Front Wheel Hub – Accumulation Of Excess Grease – Grease Deflector Ring

1997 MY-ON XK8 Range

1998 MY-ON V8 Sedan NA

ILLUSTRATION 1

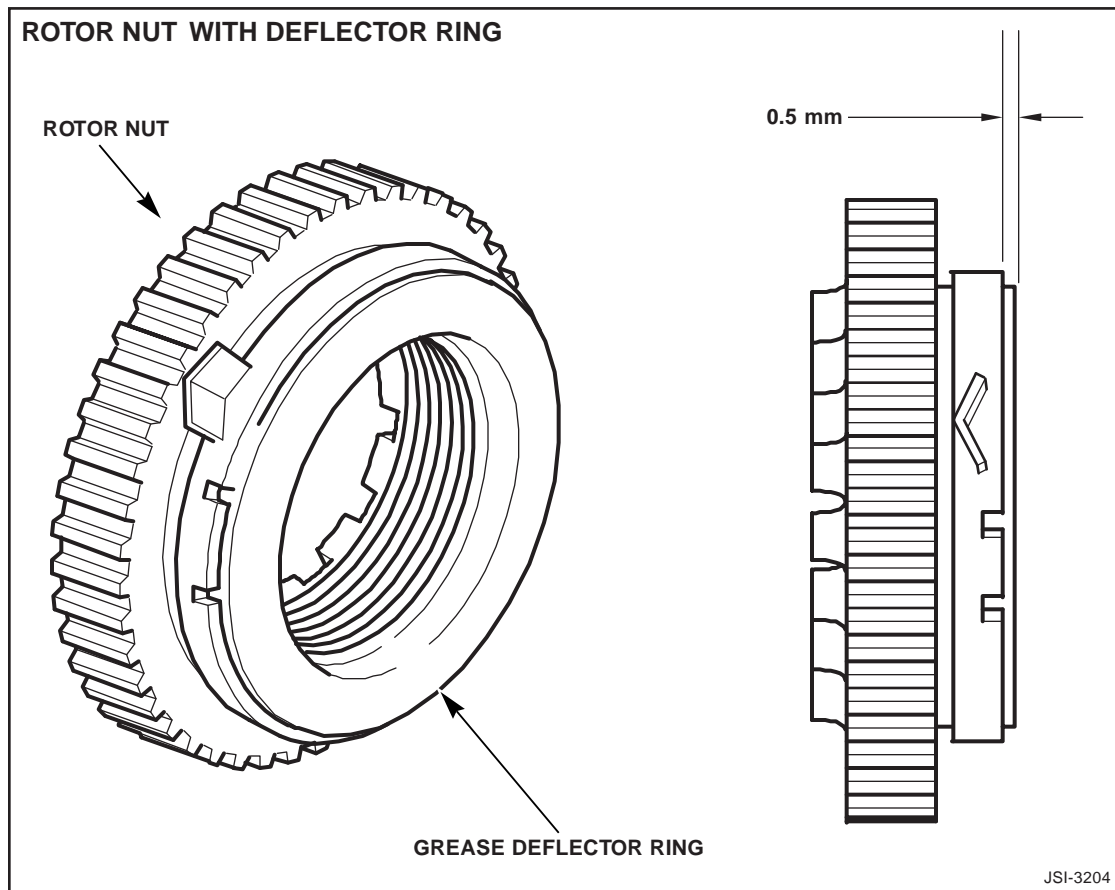
Vehicles after the above VIN are equipped with a nylon grease deflector ring on the rotor nut of each front hub. This ring prevents the build-up of excess grease near the seal which could collect dirt that could damage the seal.

When performing a repair on a 1997 MY-on XK8 that requires removing the rotor nut, install a grease deflector ring during reassembly. 1998 MY-on vehicles must always have the deflector ring reinstalled during any service to the front hub.

The deflector ring is a light interference fit on the nut and must be installed 0.5 mm from the edge of the hub as shown in Illustration 1.
